SUPPLEMENTAL/AMENDED INFORMATION
TO DRAINAGE REPORT
DATED APRIL 23, 2013

INLAND KENWORTH
Fortuna Rd West of 76th Street NW

SUMMARY OF SUPPLEMENTAL/AMENDED INFORMATION

- **REVISED ONSITE BASIN MAP
(APPENDIX B)**
- **REVISED STORM DRAIN CALCULATIONS
(APPENDIX D)**
- **INLET CAPACITY CALCULATIONS**

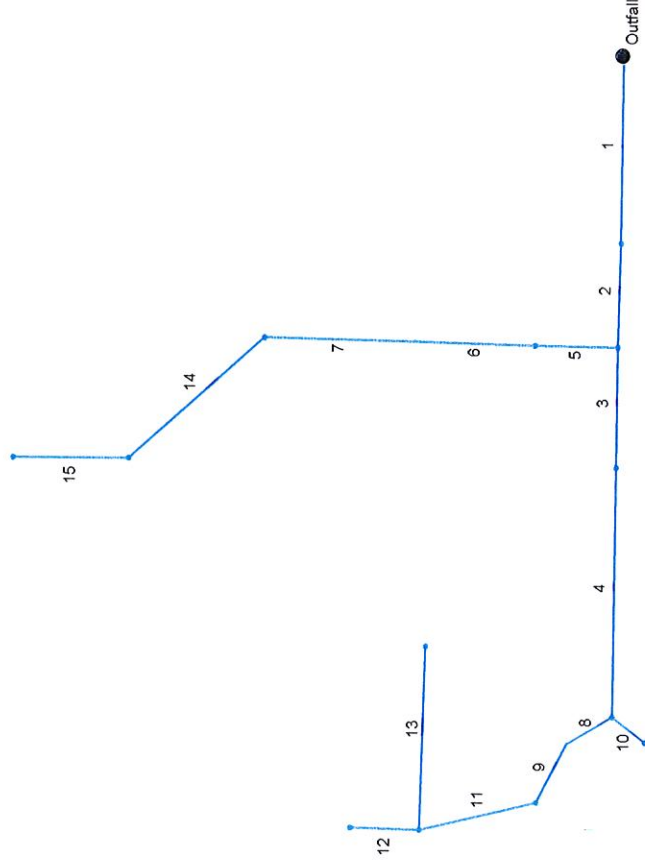
3. Flows from Basin 2 may have difficulty turning 90 degrees as they enter the channel at the northern end. Improving this entry point should help maintain flow in the channel.

4. Provide calculations to support the sizing of the channel draining Basin 2.

- Channel at east property line was eliminated and replaced with 2-Type C inlets and storm drain.
- Storm drain from inlet #1 was extended to pick up flows from loading dock area and roof drains.
- Onsite Basin Map (Appendix B) was revised.
- Hydraflow Storm Sewer Calculations (Appendix D) were revised.
- Inlet Capacity Calculations were added

1. The storm drain has been revised to provide a max. 30 degree angle of confluence—see attached grading plan and storm drain calculations.
2. Capacity calculations for inlets are included.
3. Channel has been eliminated and replaced with 2- Type C inlets and storm drain.
4. Channel has been eliminated.

West Storm Drain

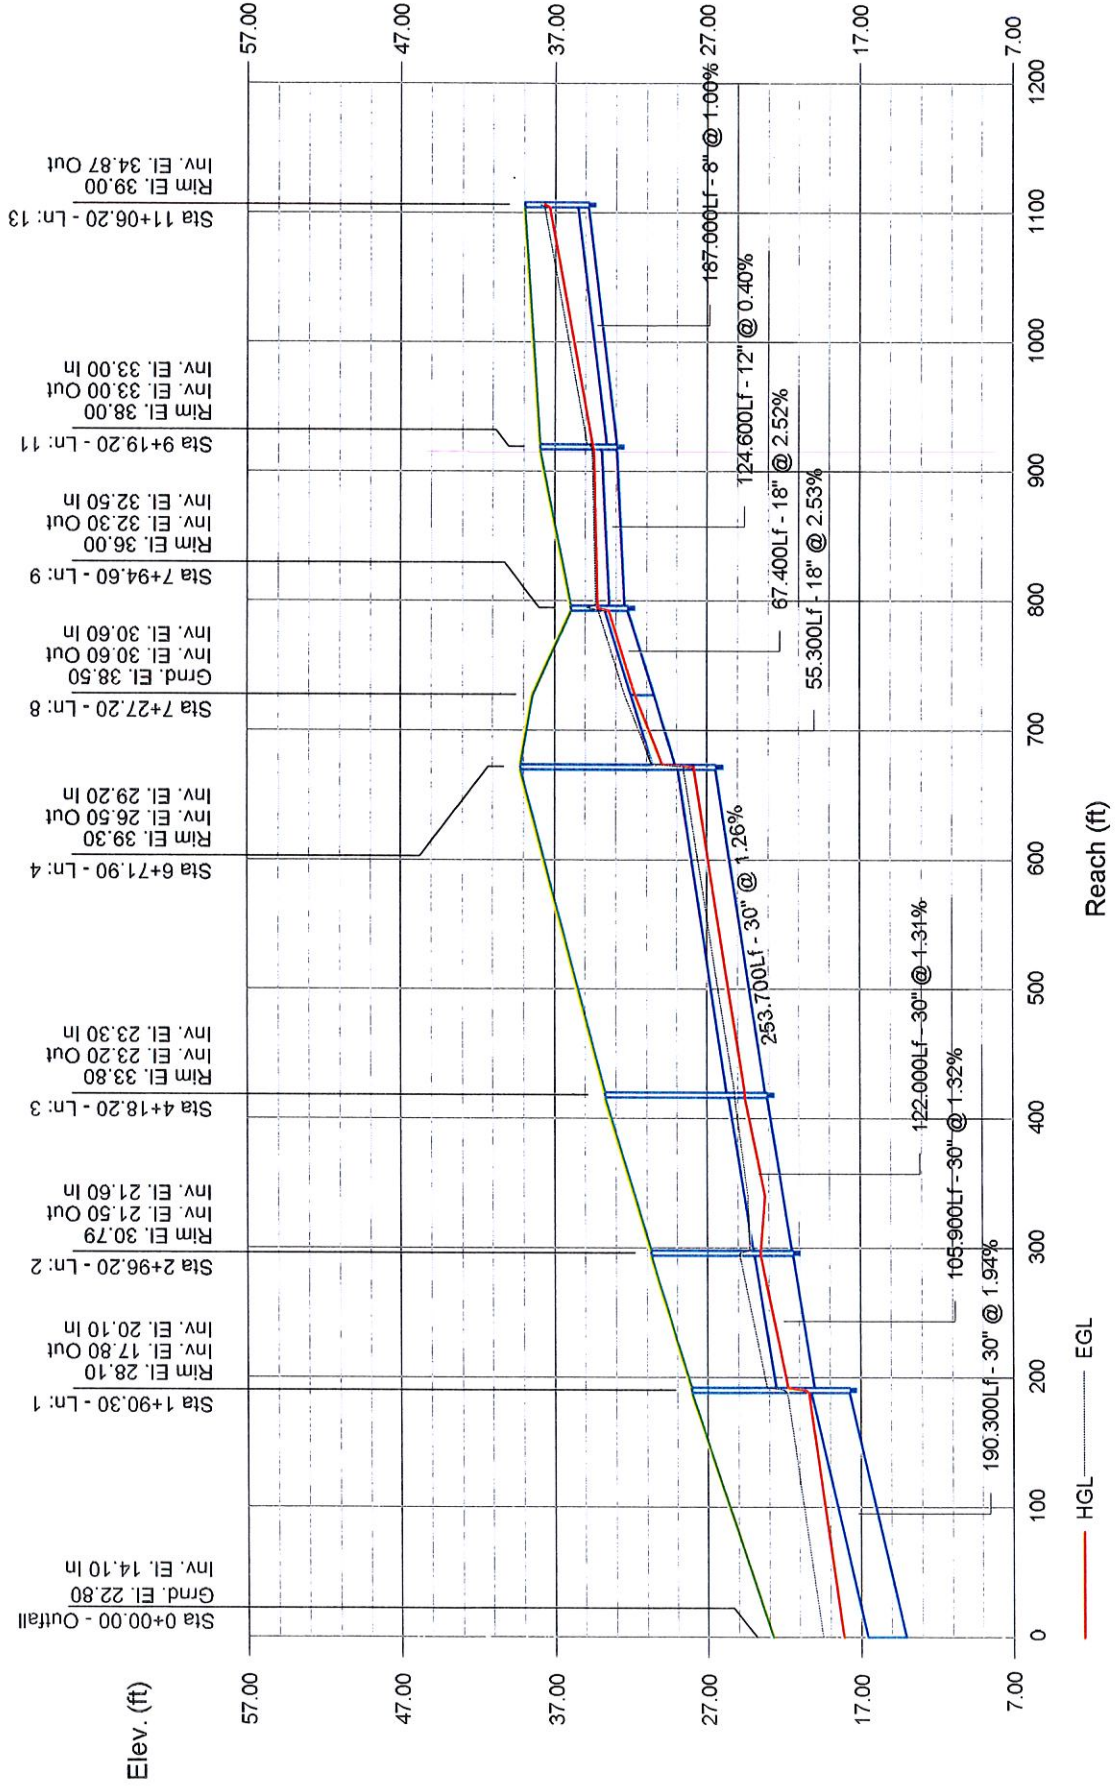
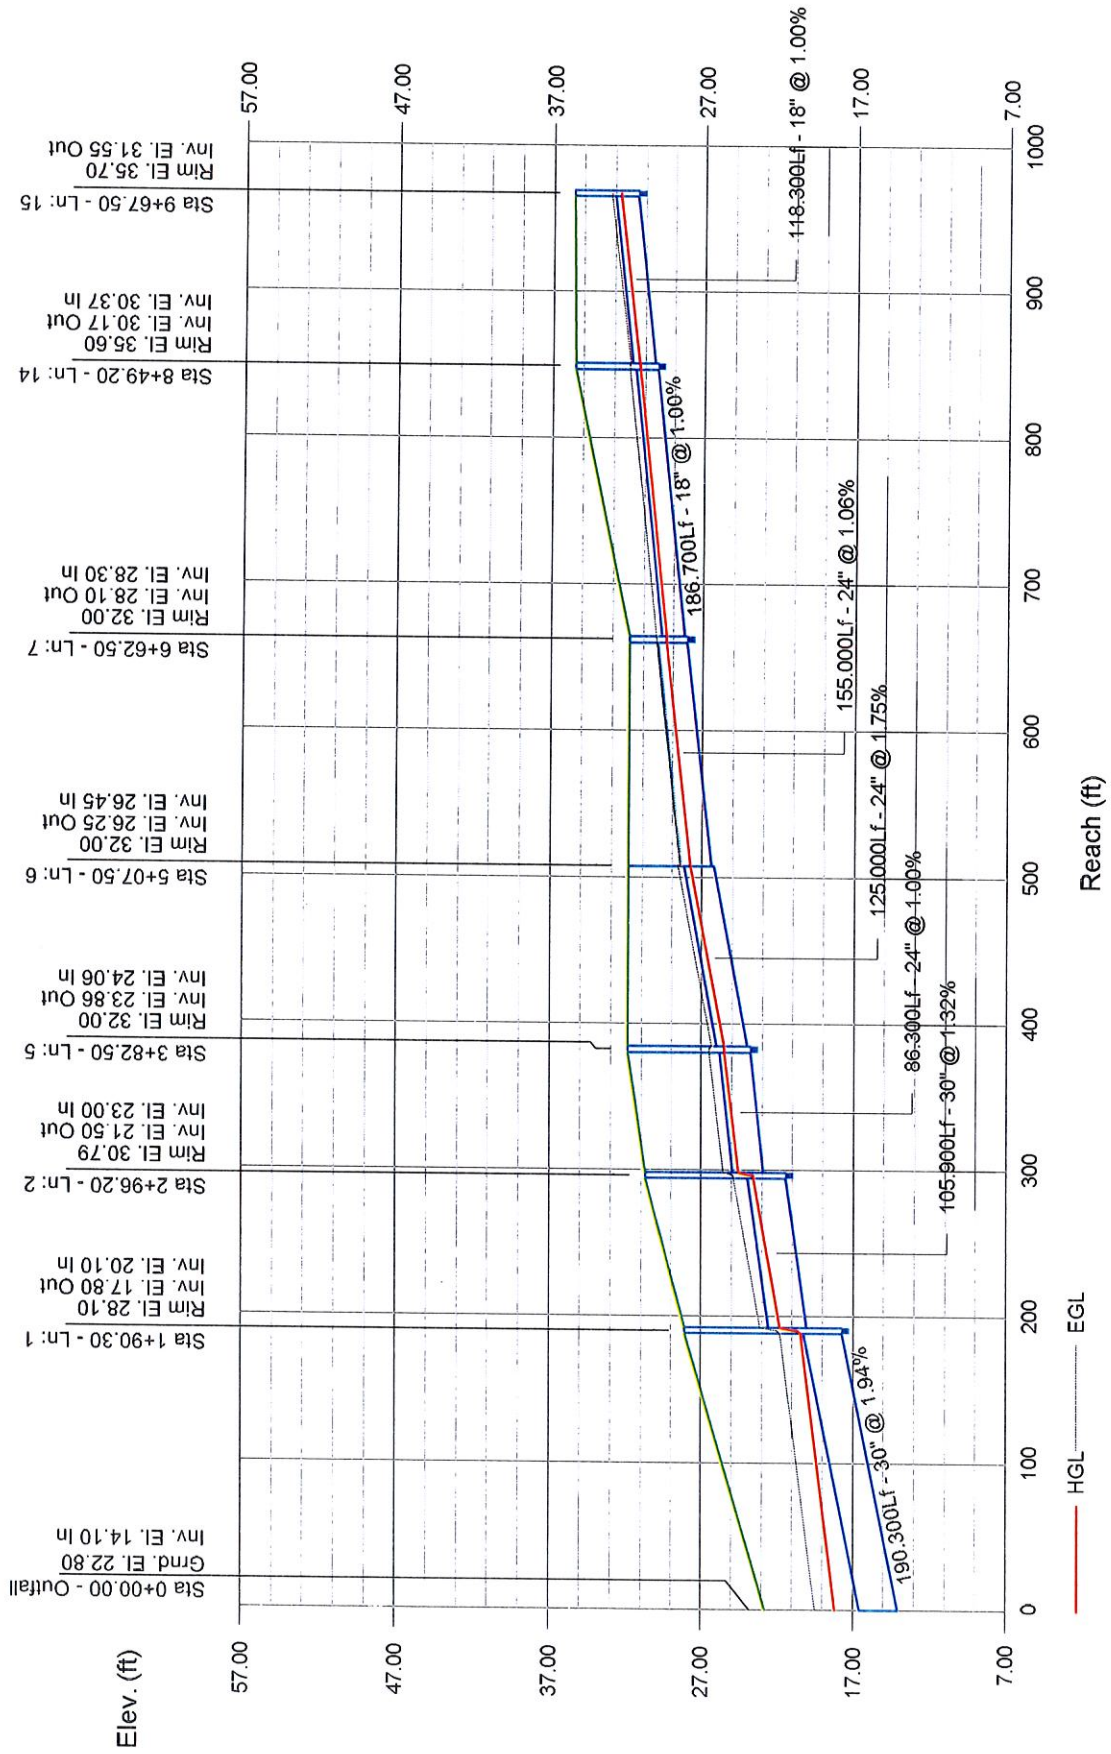
1. Per the DPM, p. 22-106, where the peak flow in the proposed lateral exceeds 10 percent of the main line, the angle of confluence should not exceed 30 degrees. This can be worked out at DRC.
